ABB-CE TRANSMITTALS OF CESSAR-DC
REVISIONS PRINTED IN AMENDMENT K

ATTACHMENT 2

CESSAR-DC CHANGES IN AMENDMENT K

Summary of Attachment 2

Figure
6.2.5-2

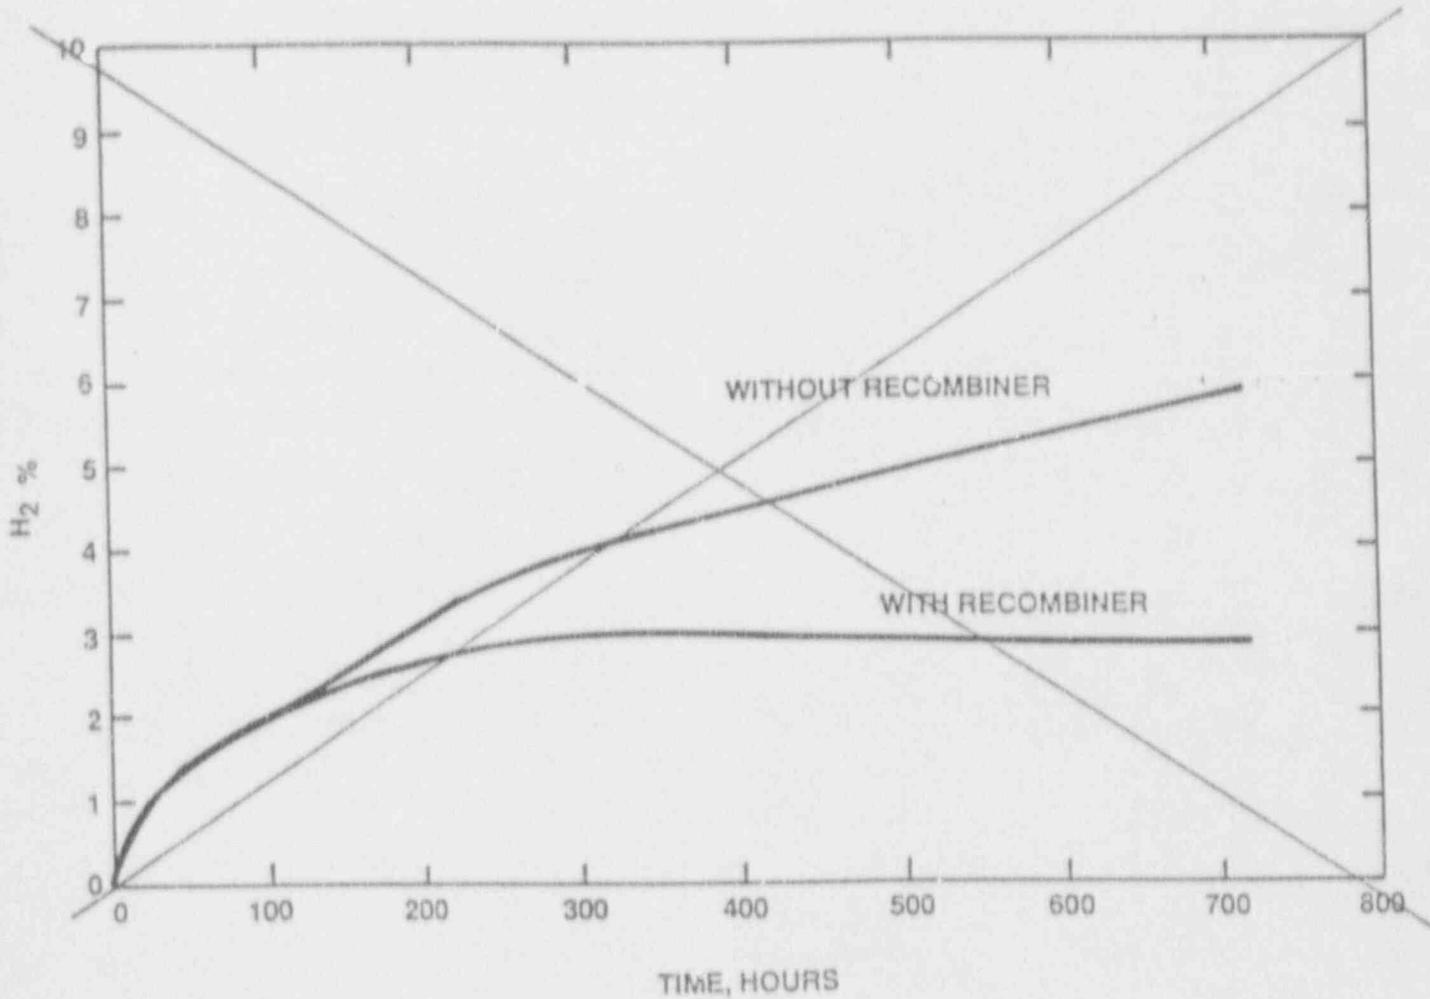
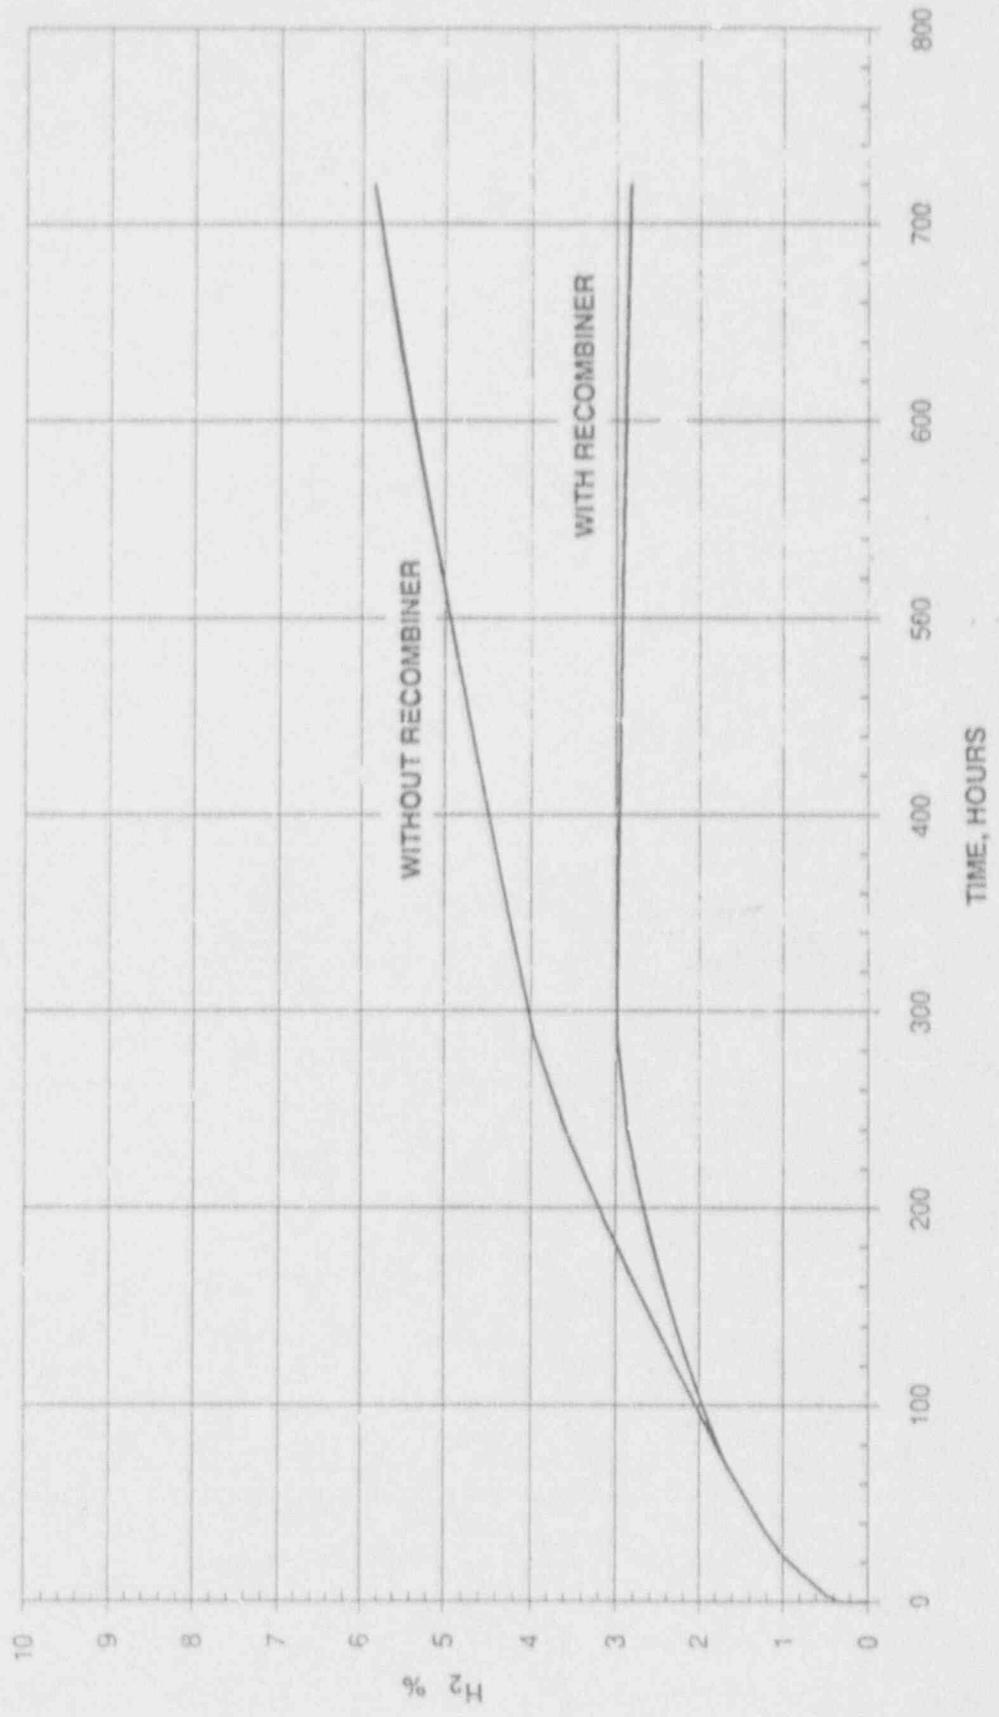
Replace With
Following Page

CONTAINMENT HYDROGEN CONCENTRATION vs TIME
AFTER LOCA (WITHOUT RECOMBINERS AND WITH A
SINGLE RECOMBINER START TIME OF 72 HOURS)

Figure
6.2.5-C

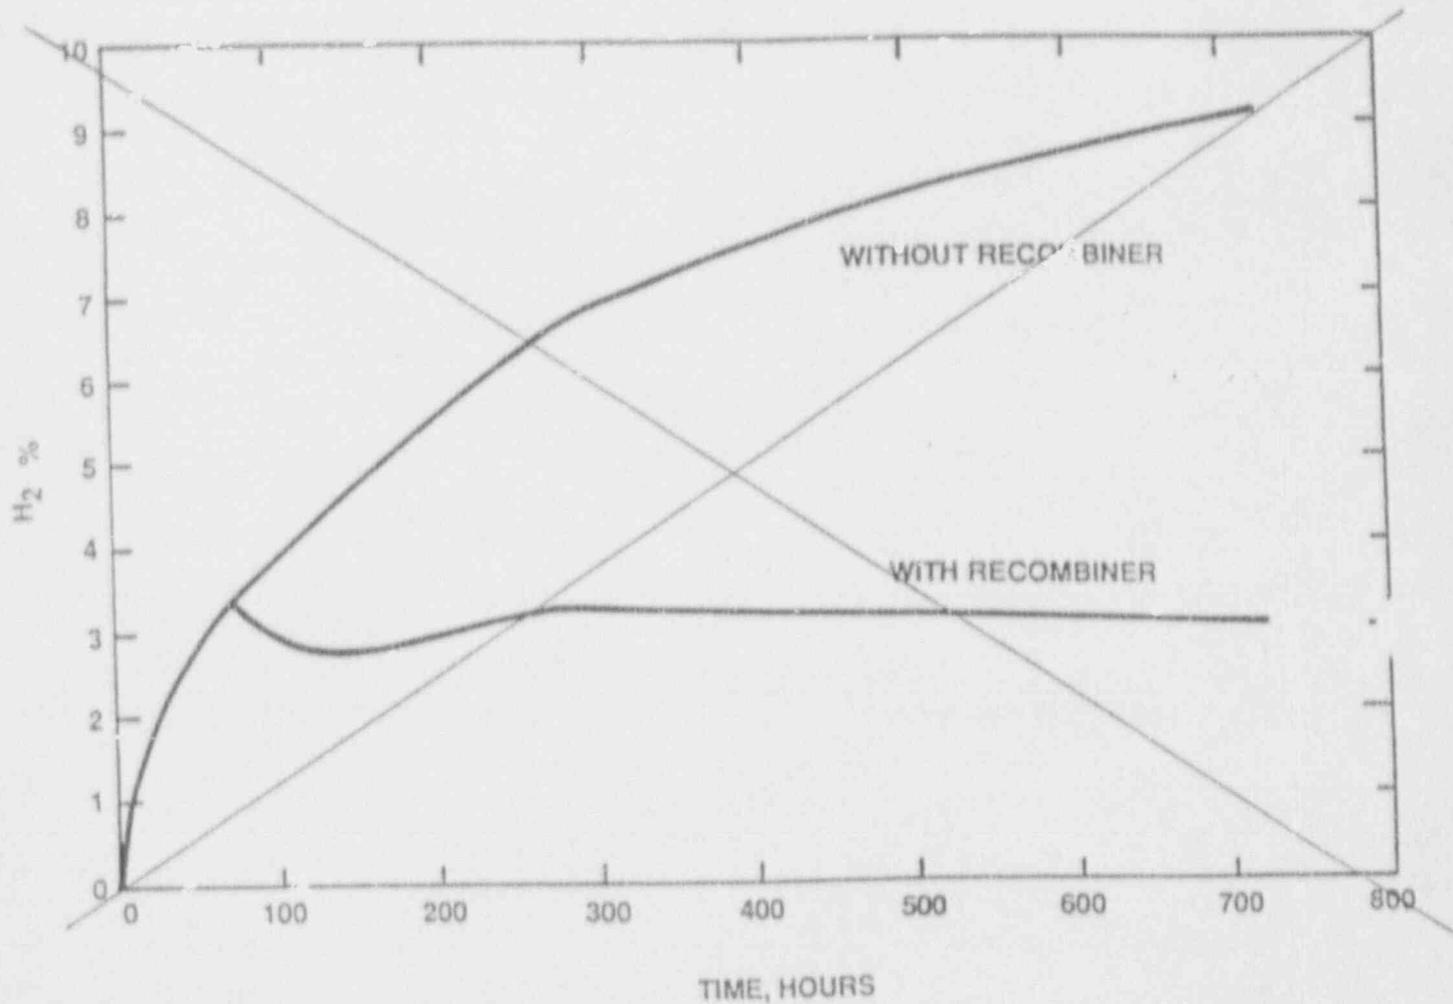
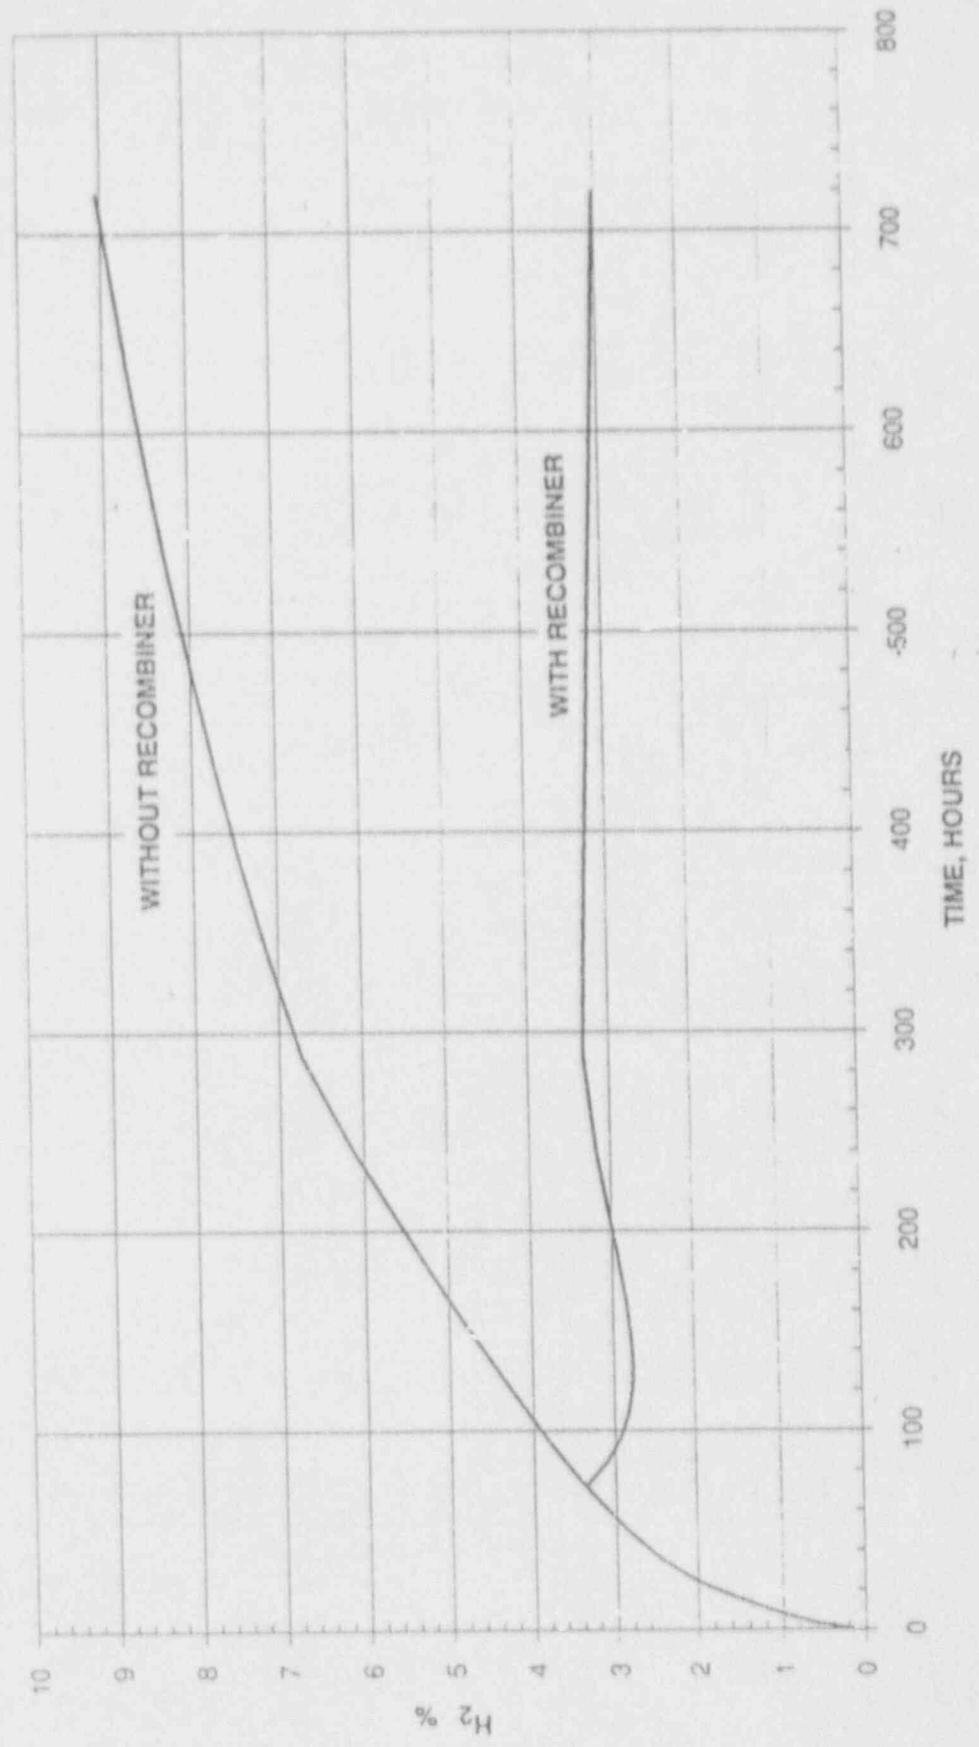
Replace With
Following Page

IRWST HYDROGEN CONCENTRATION vs TIME
AFTER LOCA (WITHOUT RECOMBINERS AND WITH A
SINGLE RECOMBINER START TIME OF 72 HOURS)
